FELDMAN KIA PRO JZ24-32 with ZMA18.746

Public hearing at the request of Feldman Automotive for Planning Commission's recommendation to City Council for a Zoning Map Amendment from Non-Center Commercial to General Business with a Planned Rezoning Overlay. The subject site is approximately 4.88-acres and is located west of Joseph Drive, south of Grand River Avenue (Section 24). The applicant is proposing to develop an automotive dealership with outdoor vehicle inventory.

PLAN REVIEW CENTER REPORT
Planning Review
 March 11, 2025
JZ24-32 Feldman Kia PRO
 Zoning Map Amendment No. 18.746

SP1.2

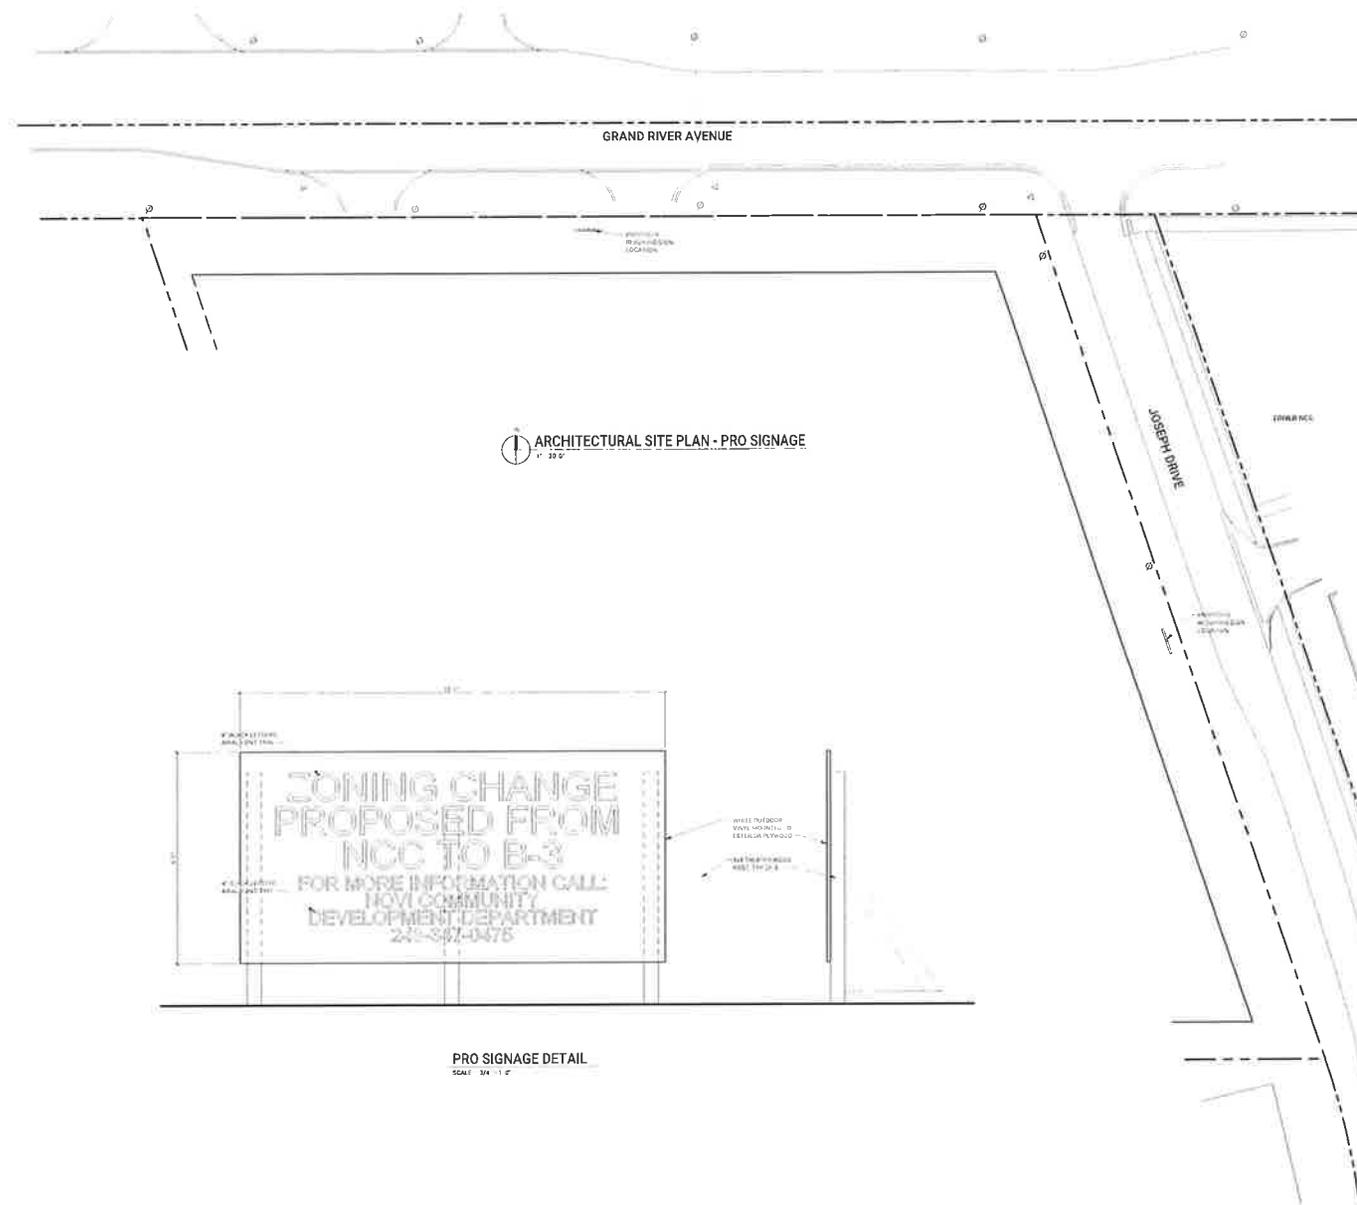
7. Deviation requested from Chapter 28 Signs, Section 28-5 table and applicable footnotes provides that with respect to wall signs a single tenant within a B-3 district is allowed one wall sign up to 250 square foot maximum. The applicant requests that, due to the nature of the business, additional wall signs be allowed to indicate dealership branding and to provide wayfinding for the customers. The applicant is requesting two wall-mounted brand signs, one dealer sign and one directional sign for service reception area. The total wall signage area is approximately 118 square feet. ***As it is unclear whether future deviations from the sign code would be needed,***

4. **DEVELOPMENT/BUSINESS SIGN:** Chapter 28 Signs, Section 28-5 table, and applicable footnotes provides that with respect to wall signs a single tenant within a B-3 district is allowed one wall sign up to 250 square foot maximum. Additional requirements (Section 28-5.b.1.b) indicates the maximum wall sign area as it correlates to the setback distance for the adjacent road. Due to the nature of the business, it is respectfully requested that additional wall signs be allowed to indicate dealership branding and to provide wayfinding for the customers. Dimensions indicating the distance from the building to the centerlines of the roads are located on the preliminary site plan. The applicant is requesting two wall-mounted brand signs, one dealer sign and one directional sign for service reception area. The total wall signage are is approximately 118 square feet.

Staff Comment from the March 11, 2025 Planning Review: See staff comments on signage on page 3-4 of this review. The applicant was asked to submit Sign Permit Applications for each sign proposed in order to fully determine the deviations required for the proposed signage.

A2.1

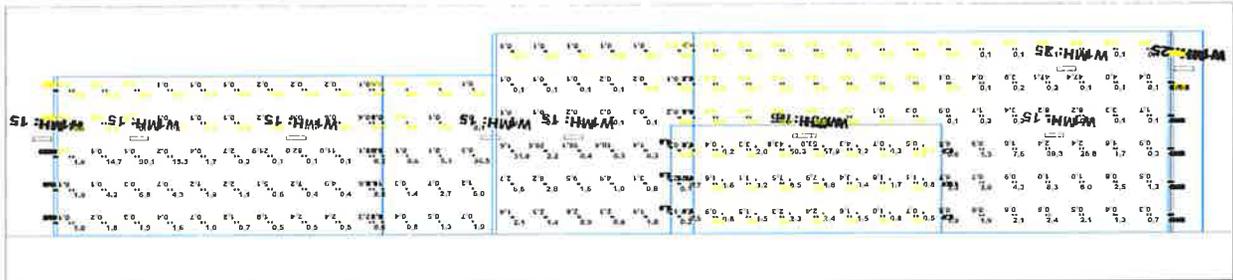
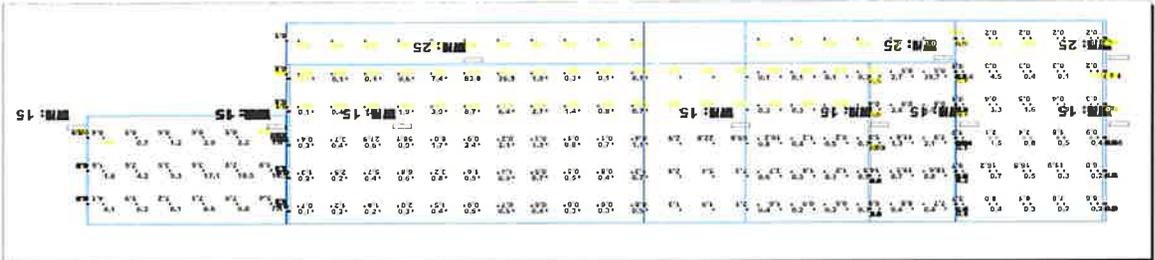
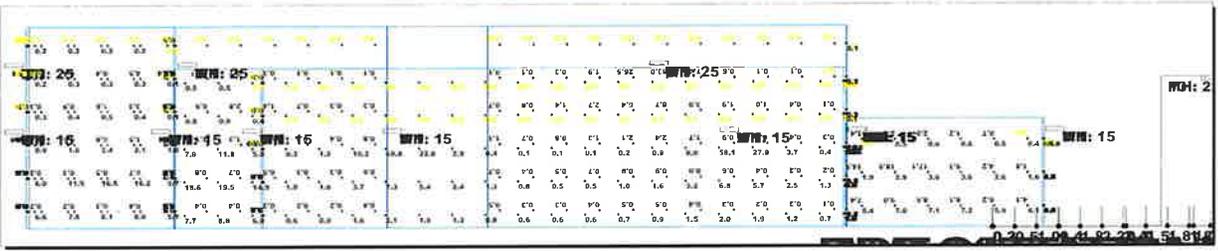
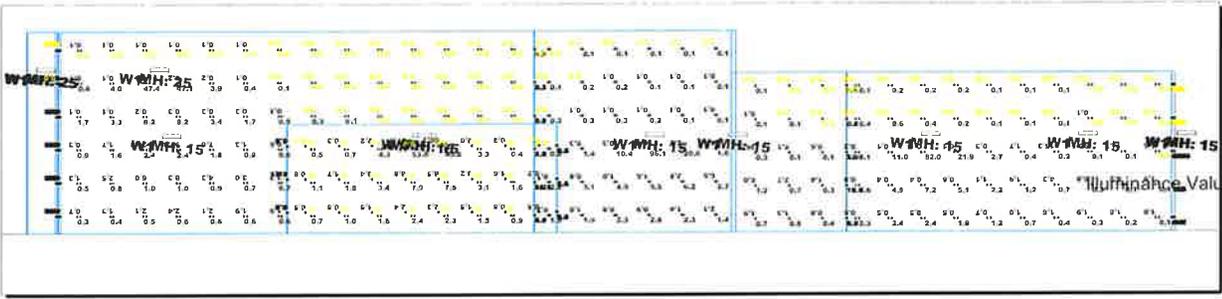
6. Façade deviation from Section 5.15 for the north facade to contain 0% brick rather than the minimum 30% brick. The front consists of 70% showroom glass and 30% flat metal panels. *The deviation is supported as the addition of brick would not offer an enhancement to the design.*

2. **FAÇADE WAIVER:** Section 5.15 – A minimum of 30% of the front façade is required to be brick.
Staff Comment from the March 11, 2025 Planning Review: *As noted in the façade review, the front façade consists primarily of showroom glass, which is not regulated by the façade ordinance. "In this case the addition of brick would not enhance the front façade and all other façades have large percentages of brick. For this reason, we recommend that the design is consistent with the intent and purpose of the façade ordinance and that a Section 9 façade waiver be granted for all underage of brick on the front façade.*

Staff Comment: As noted in the Façade Review, the front façade consists primarily of showroom glass, which is not regulated by the façade ordinance. "In this case the addition of Brick would not enhance the front façade and all other facades have large percentages of brick. For this reason, we recommend that the design is consistent with the intent and purpose of the Façade Ordinance and that a Section 9 Façade Waiver be granted for the underage of Brick on the front facade."
